SUNDRY NOTICES AND REPORTS ON WELLS

**Myers Langlie Mattix Unit #269
OXY USA WTP Limited Partnership
February 26, 2008
Plug and Abandon
Conditions of Approval**

OXY USA WTP LP - Proposed
Myers Langlie Mattix Unit #269
API No. 30-025-32556

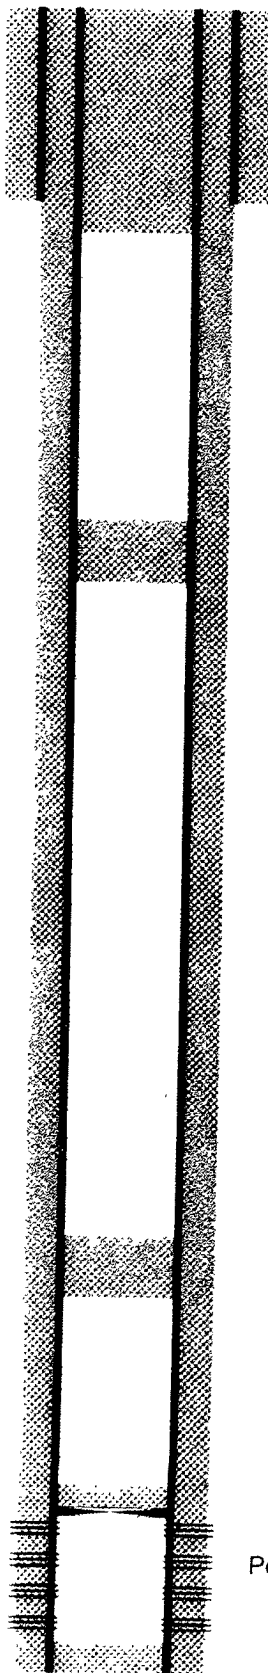
1. Ok
2. Plug to be set from 2905-2740', minimum 25 sacks. WOC 4 hours. Plug to be tagged at 2740' or shallower.
3. Plug to be set from 1290-1180', minimum 25 sacks. WOC 4 hours. Plug to be tagged at 1180' or shallower.
4. Ok
5. Cut casing, install dry hole marker and clean location.
